AMENDMENTS TO THE DRAWINGS

FIG.1
Prior Art

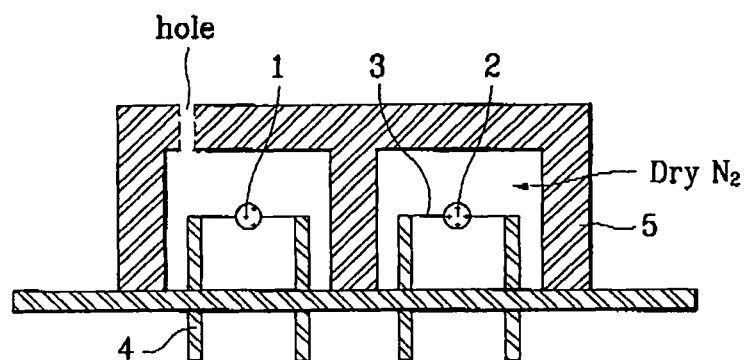
Fig. 1 is identified as prior art and Fig. 7 has been amended to show the thermal conductive film 55a.
